Site Plan SP #344

STAFF REPORT TO THE PLANNING COMMISSION

SUBJECT: Fisher Contracting Storage and Shop Building

LOCATION: 3401 Contractor Drive

ENLARGED SITE PLAN

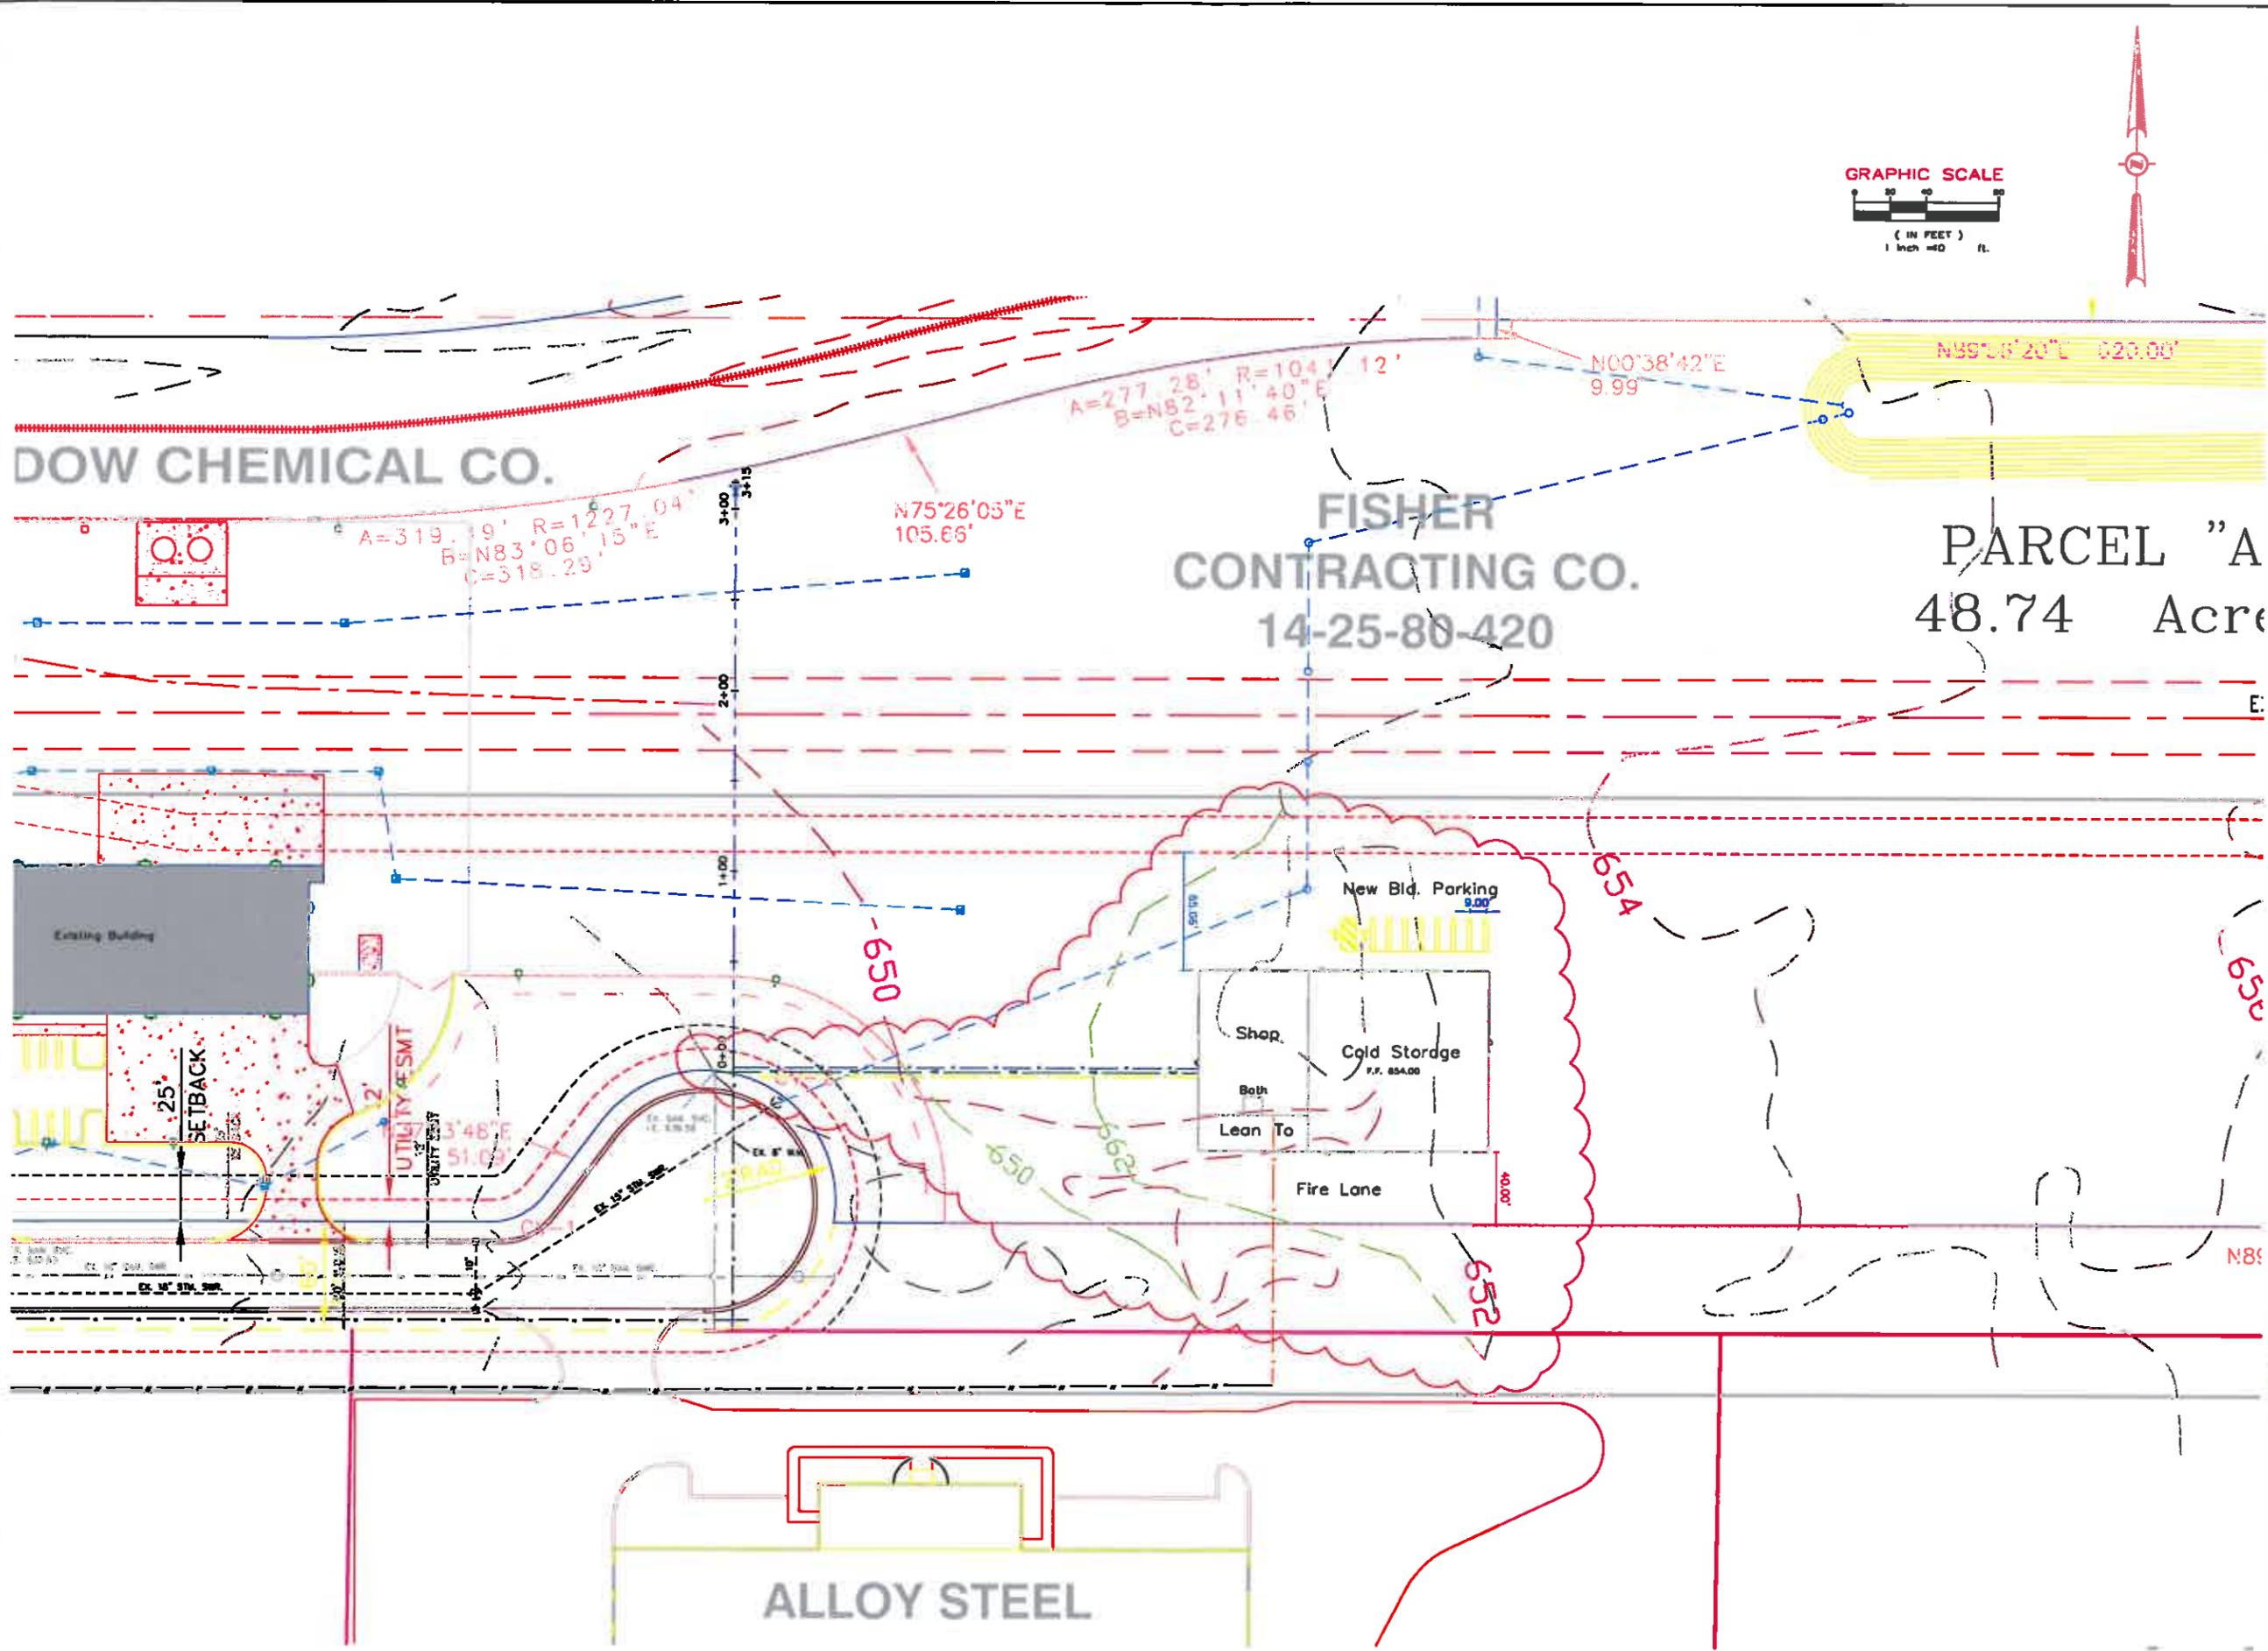
The City Fire and Utility Departments have indicated that an additional fire hydrant is needed to provide coverage for the new building. The applicant has indicated that revised plans will be submitted ahead of the meeting indicating the new hydrant location and the required public easement surrounding the water main.

1. A final stormwater management permit amendment must be approved by the City Engineering Department.
2. A final soil and sedimentation control plan must be approved by the City Building Department.
3. An additional fire hydrant shall be added along the proposed water service line.
4. Required water utility easement documents shall be submitted for review and approval by the City Engineering Department and the City Attorney.
